## 7 INSTRUMENTATION AND CONTROLS

This chapter presents the U.S. Nuclear Regulatory Commission (NRC or Commission) staff's (herein after referred to as the staff) review of the instrumentation and controls (I&C) for the NuScale Power, LLC (NuScale), small modular reactor (SMR) nuclear power reactor design certification application (DCA), Revision 2. This is part of the design certification review conducted by the NRC staff under Title 10 of the *Code of Federal Regulations* (10 CFR) Part 52, "Licenses, Certifications, and Approvals for Nuclear Power Plants." The description of the I&C systems includes the overall design bases, system classifications, functional requirements<sup>1</sup>, and system architecture, which encompasses all I&C systems and components (i.e., hardware, software, firmware, and other forms of complex logic) and areas such as software tools and equipment that are used for the I&C design or are connected to the I&C systems or components for testing.

**Figure 7.2.7-1: Setpoint relationships during surveillance testing and calibration<sup>4</sup>**

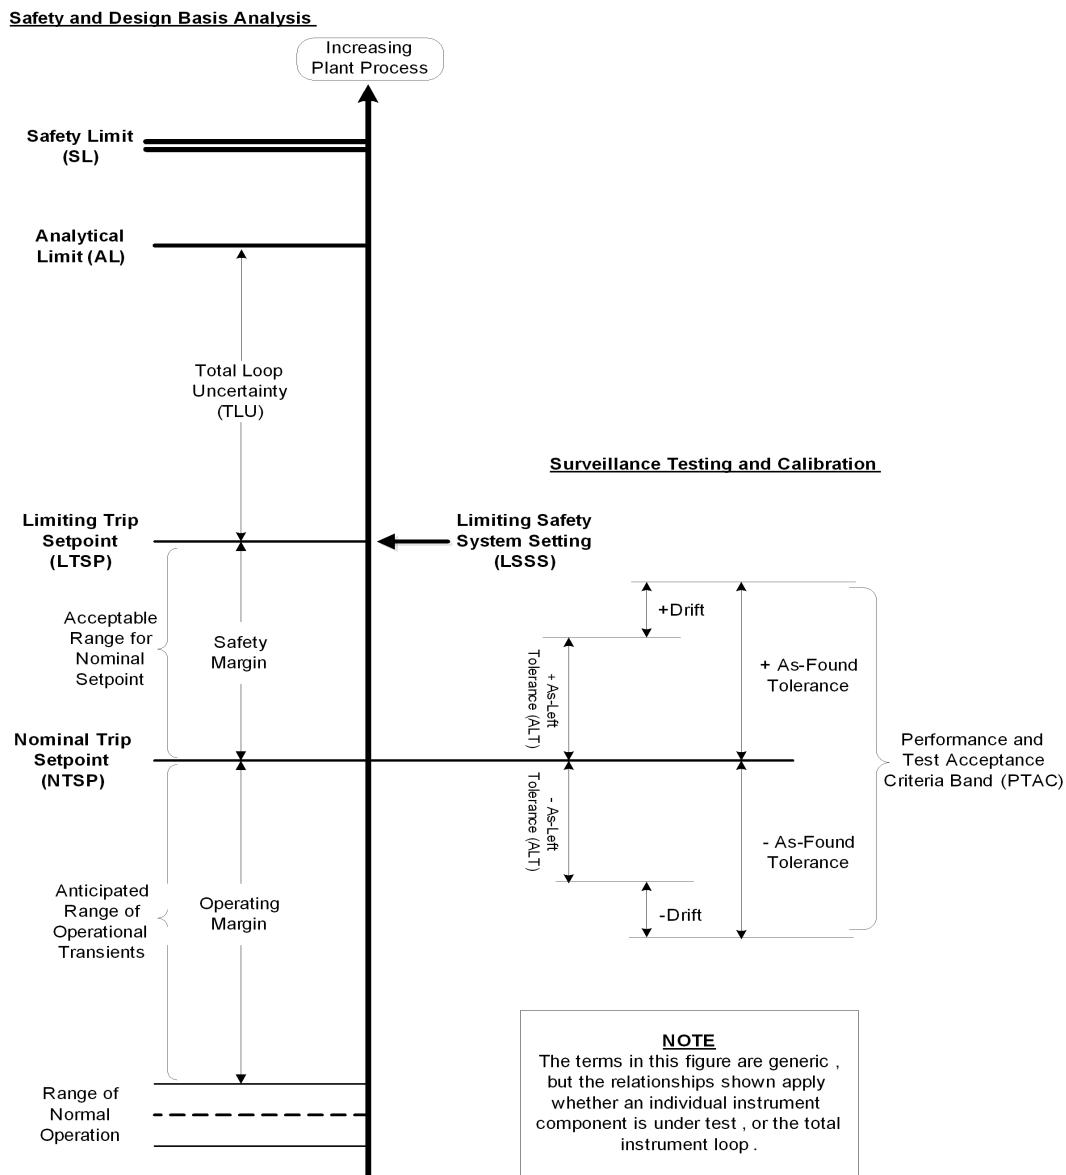
In the NuScale methodology, the AL is established to assure that a trip occurs before the SL is reached. The purpose of an LSSS is to assure that a protective action is initiated before the

process conditions reach the AL. NTSPs are chosen based on the LSSS and to minimize spurious trips close to the normal operating point of the process. Figure 7.2.7-1 below provides a pictorial representation of the NuScale setpoint methodology relationships.

This figure is intended to provide relative position and not to imply direction. Sections 4.1.3 and 4.1.4 in TeR-0616-49121 define LTSP as an LSSS and also define NTSP as the desired value of the measured variable at which an actuation occurs. The calculation of the LTSP value is given in TeR-0616-49121, Section 4.2, Equation 4-1, as  $LTSP = AL \pm TLU$ , where TLU is the total channel uncertainty.
